#### KAWARTHA PINE RIDGE DISTRICT SCHOOL BOARD

#### Interior Renovations to Camborne Public School

#### ADDENDUM NO. 1

Project: Kawartha Pine Ridge District School Board

#### 1. 1/A201: Demolition Floor Plan:

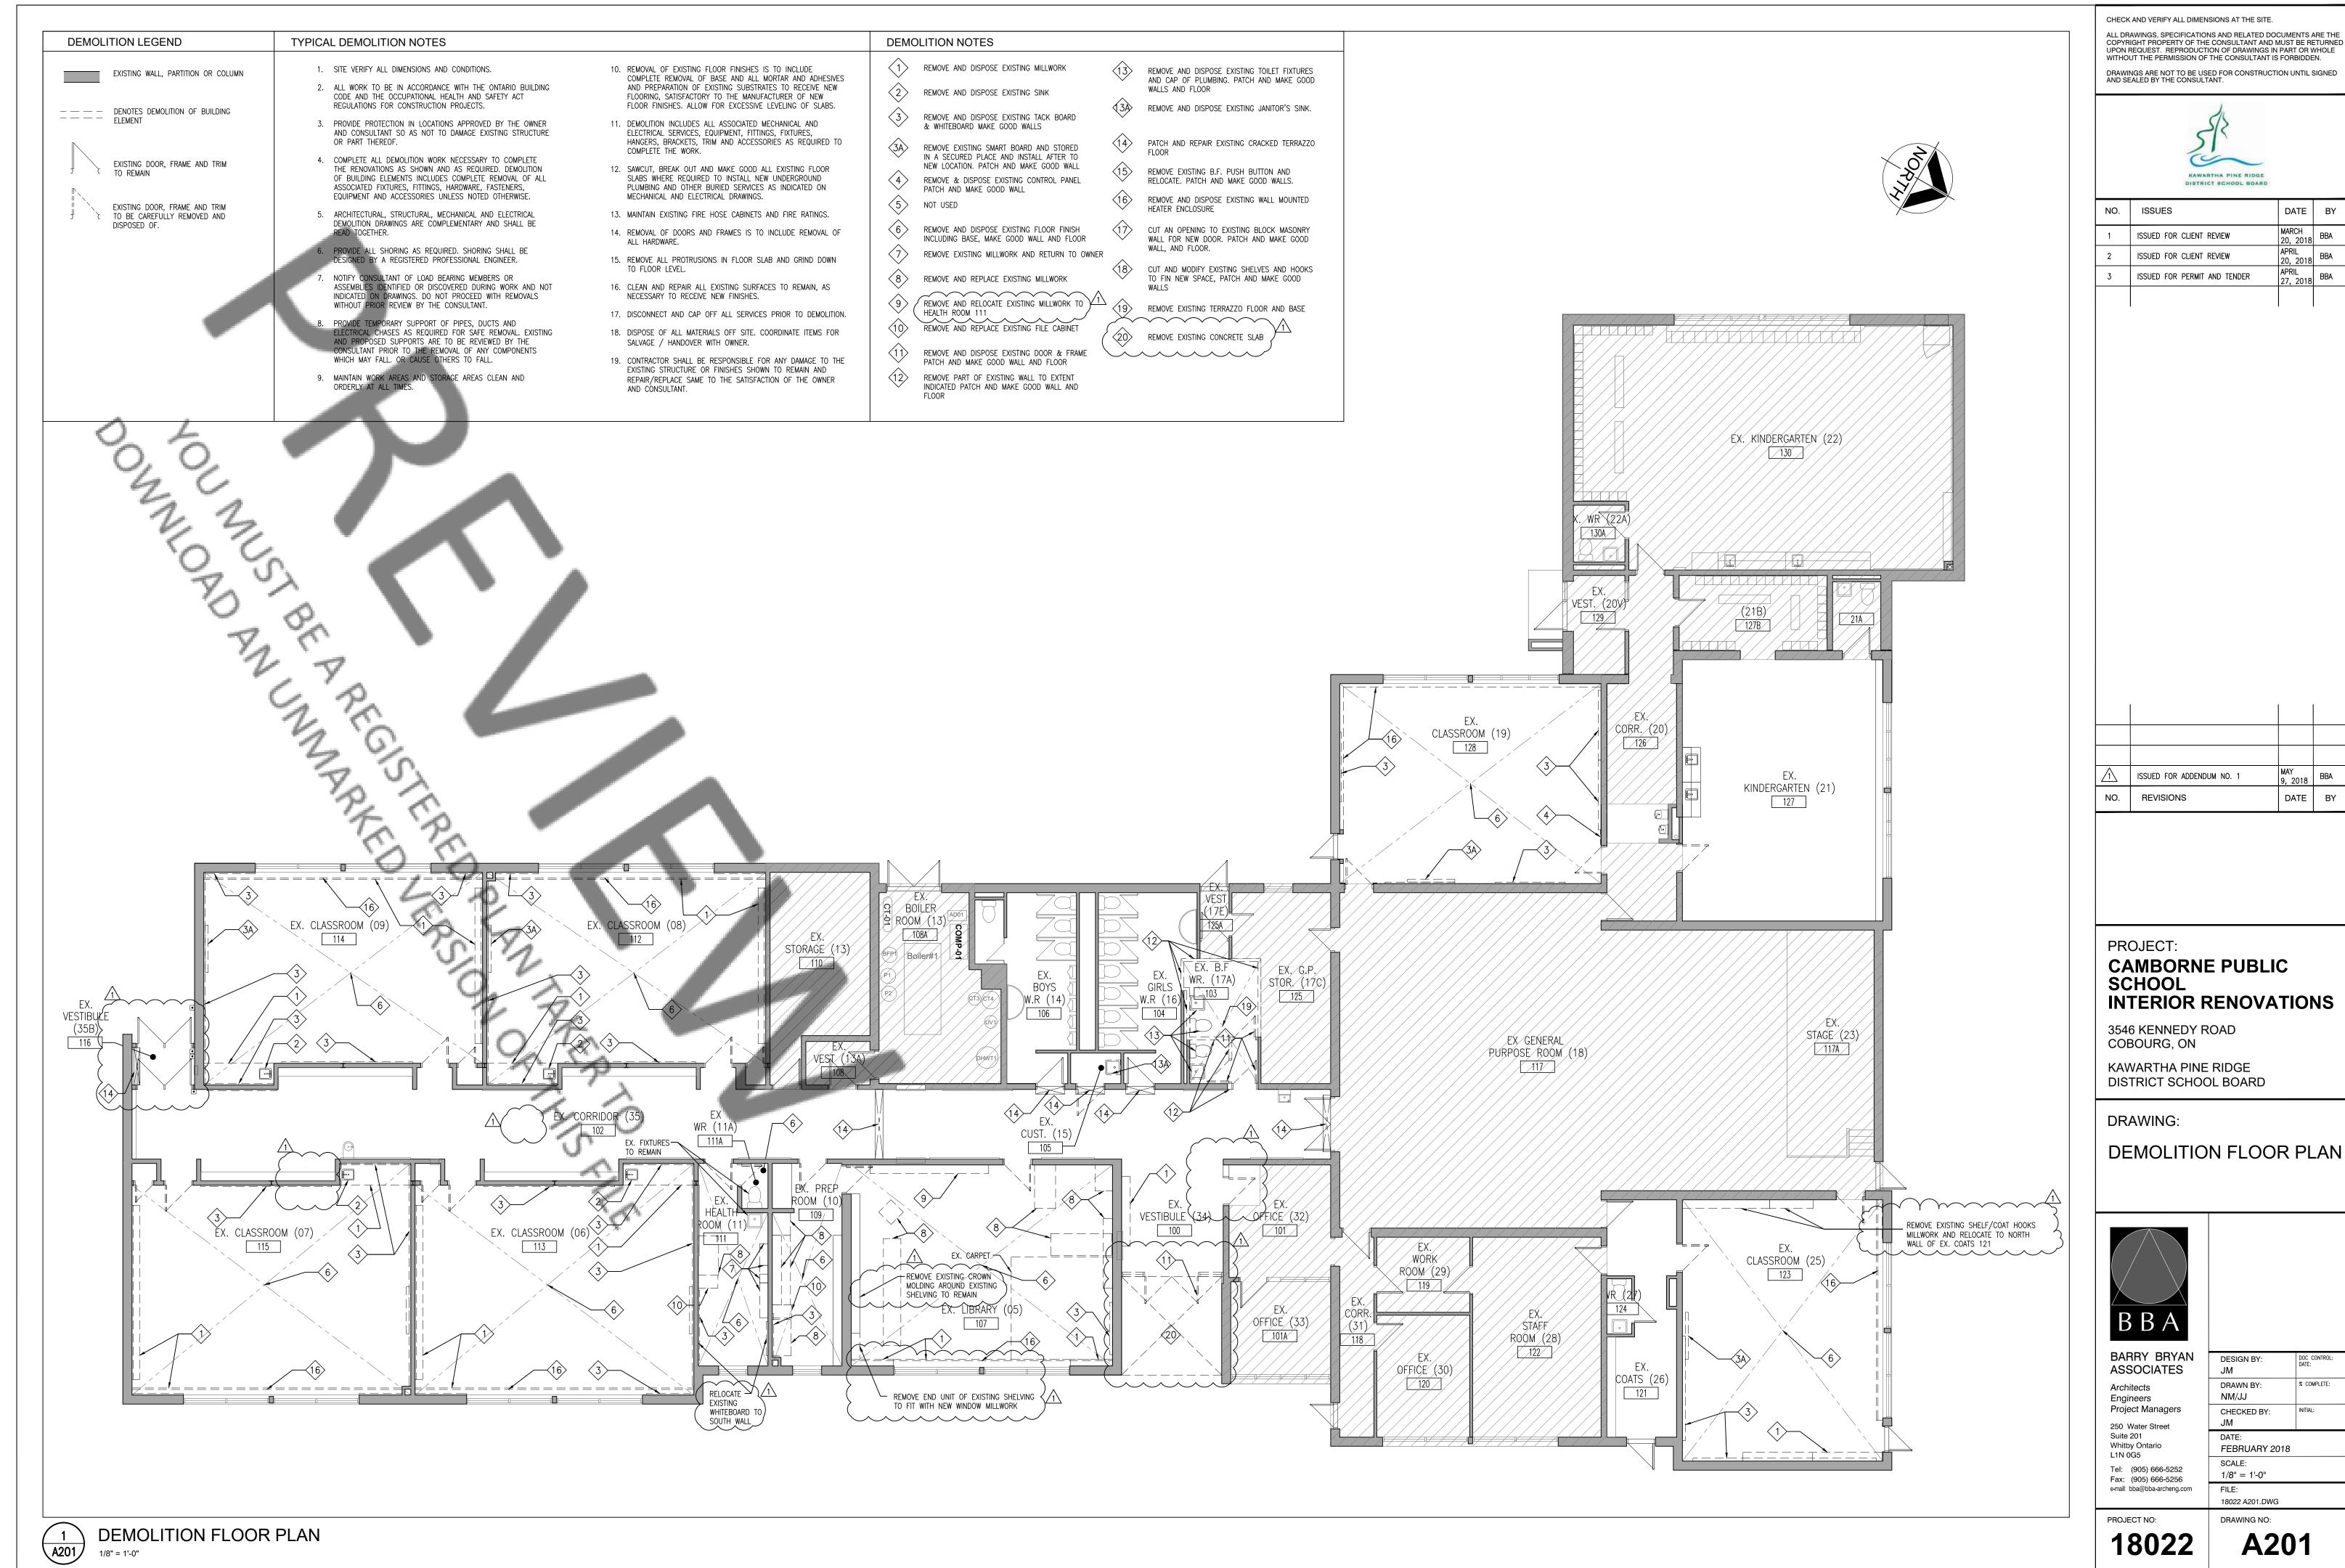
#### 1. Existing Vestibule 100:

1. At the main entrance, remove the existing concrete slab and soil to prepare for new concrete frost slab to make entrance barrier-free. See notes under Drawing A203: Floor Plan.

#### 2. Existing Office 101:

1. Remove existing door and frame and block above, to prepare for new door, frame and block to be added.

#### 3. Existing Corridor 102:

1. The Note "6" in this corridor has been removed, since the existing terrazzo flooring is to remain and be patched (not removed).

#### 4. Existing Library 107:

1. The existing shelving unit at the south wall is to remain. Cut one section of this shelving unit off so it allows space for the new window millwork, and remove crown moulding.

- 5. Existing Health Room 111:
  - 1. At the south wall, the existing tackboard is to remain.
  - 2. Delete arrow from Note "3" to the north wall white board. The existing white board is to be relocated from the north wall to the south wall.

#### 6. Existing Classroom 115:

1. The proposed new door to this room from Existing Corridor 102 is deleted.

#### 7. Existing Vestibule 116:

1. This existing Vestibule, doors, power door operators and push buttons are to remain.

#### 8. Existing Classroom 123:

1. Delete Note "8" at existing millwork. This existing shelf/coat hook millwork at the west wall is to be relocated to the north wall of Existing Coats 121. Patch and make good all finishes.

#### 9. Demolition Notes:

- 1. Revise Note "9" to read "9. Remove and relocate existing millwork to Existing Health Room 111."
- 2. Revise Note "20" to read, "20. Remove existing concrete slab."

#### 1. 1/A202: Reflected Ceiling Plan:

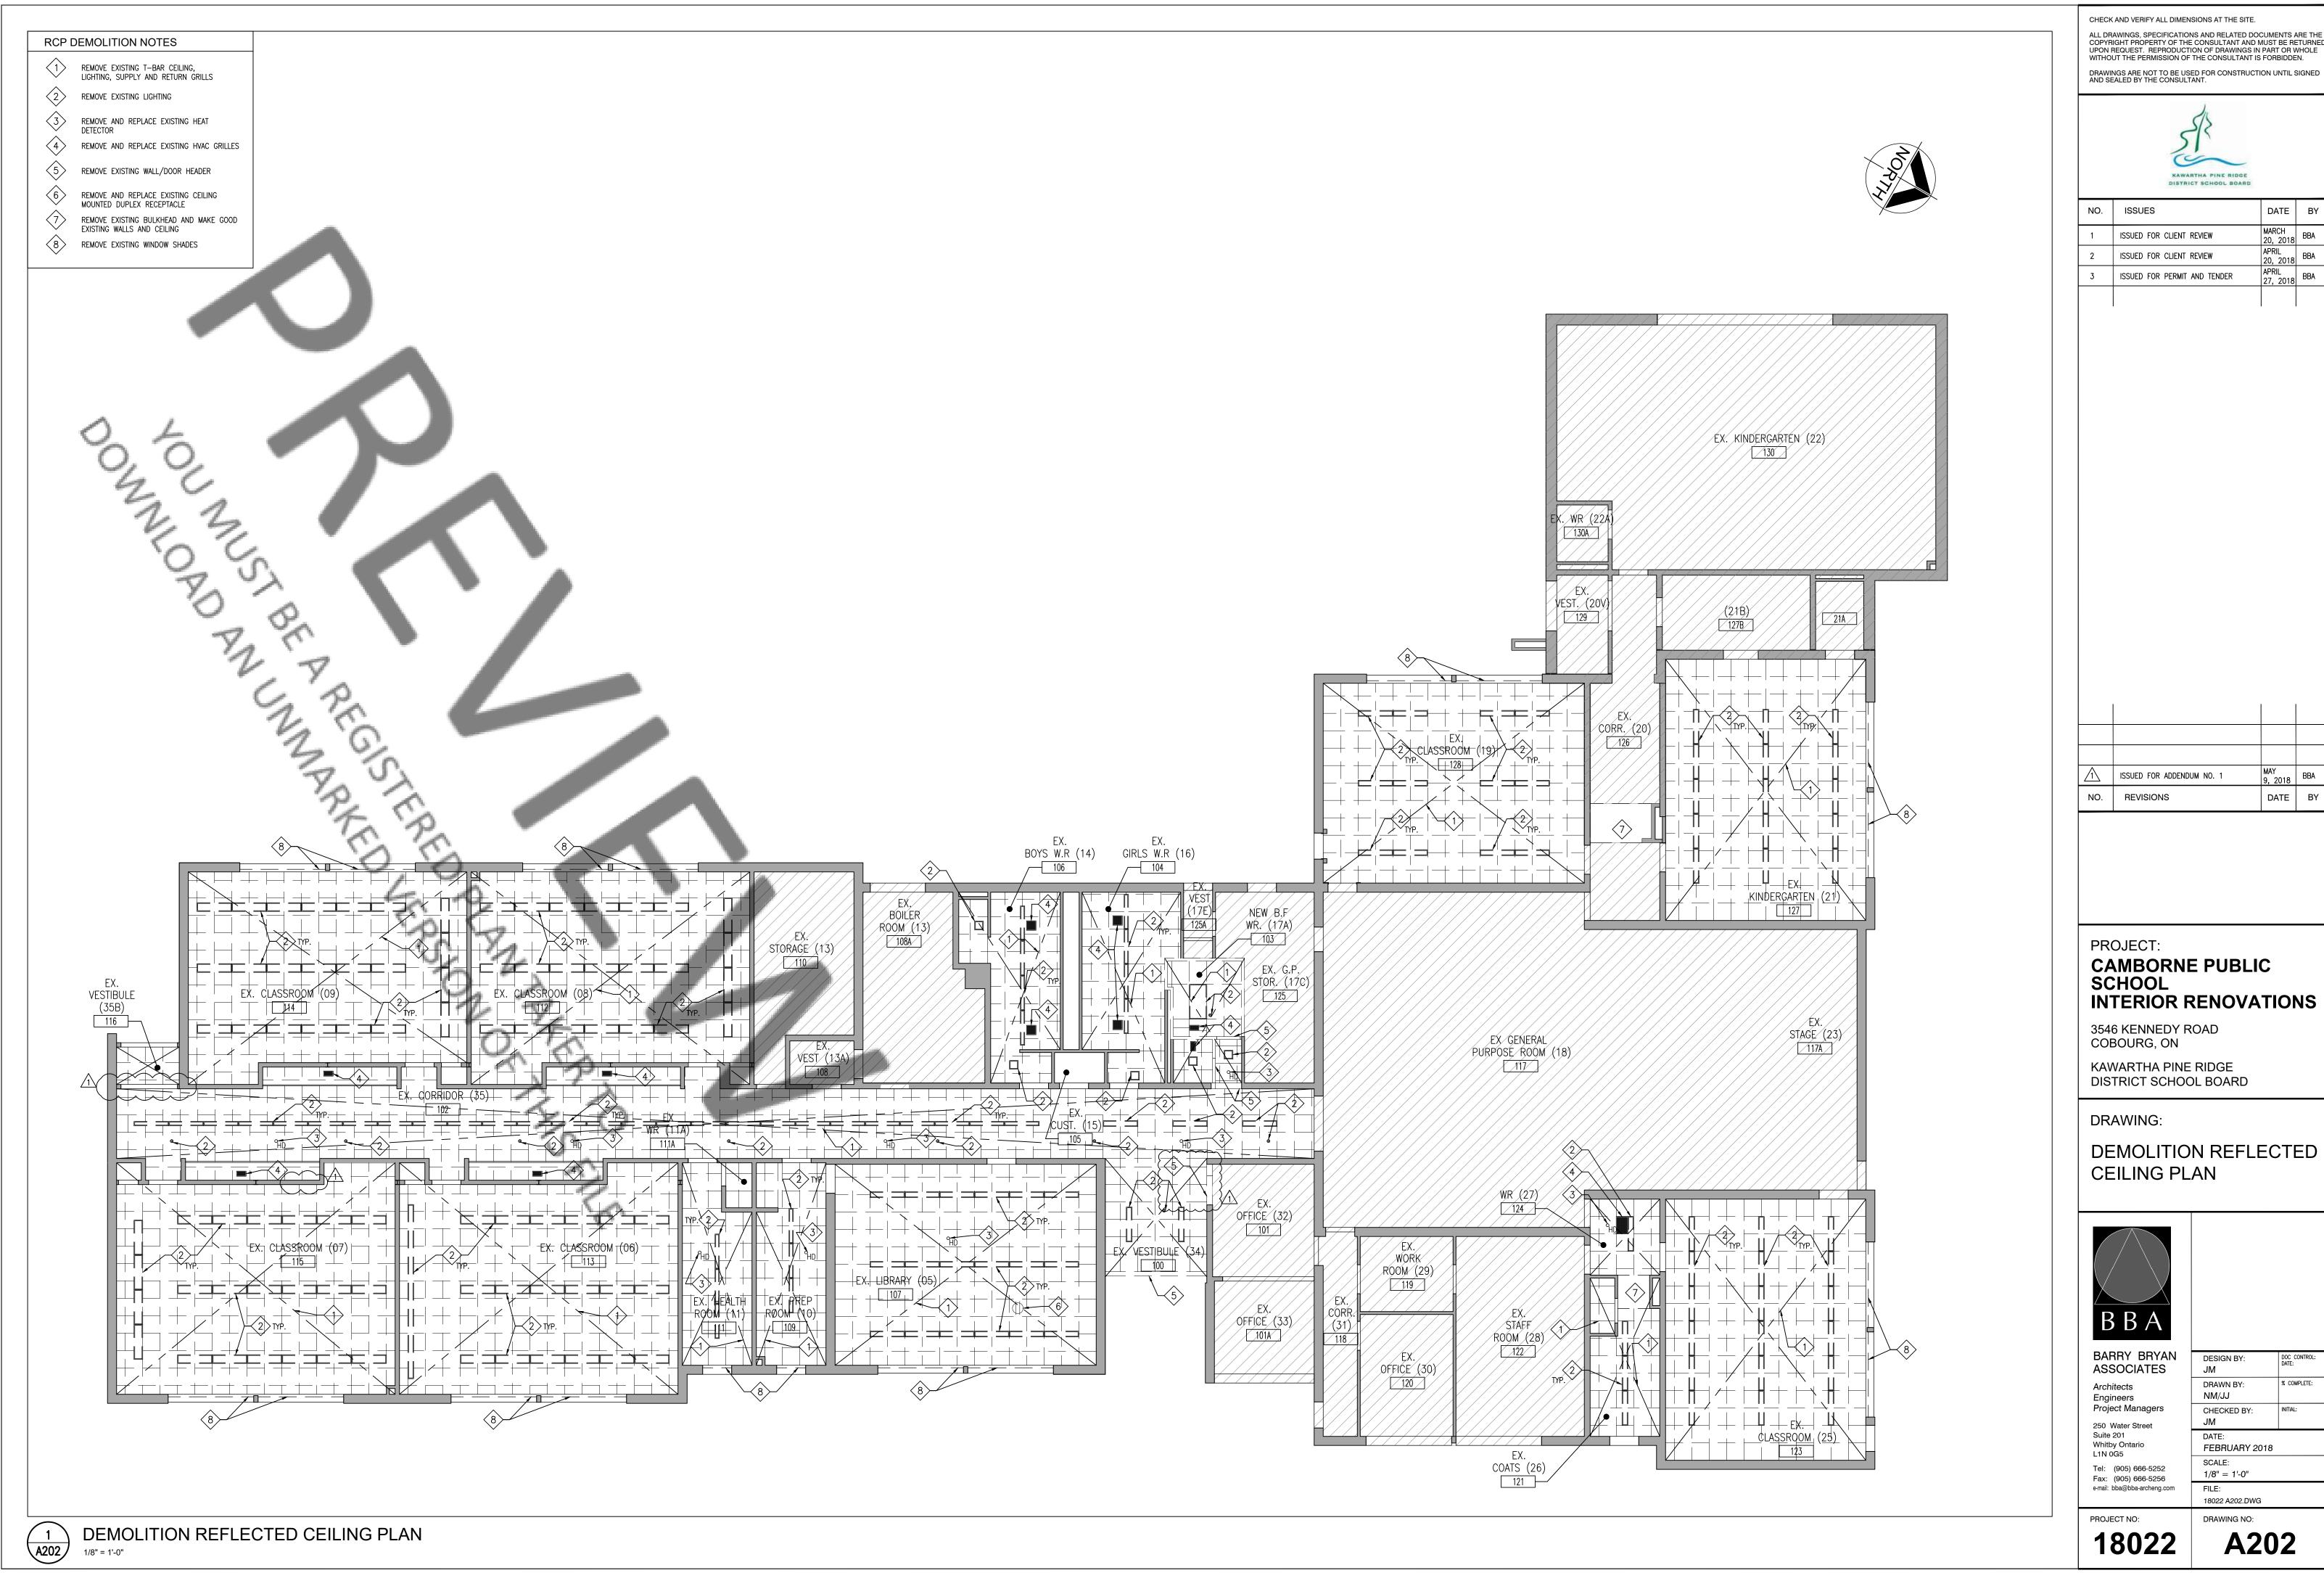
- 1. Existing Vestibule 116: the existing bulkhead above the interior pair of doors is to remain.
- 2. Existing Classroom 115: the existing wall between this room and Corridor 102 is to remain. The proposed single door and frame have been deleted.
- Existing Office 101: the existing door and frame are to be removed. Provide new lintel and block above new hollow metal door frame.
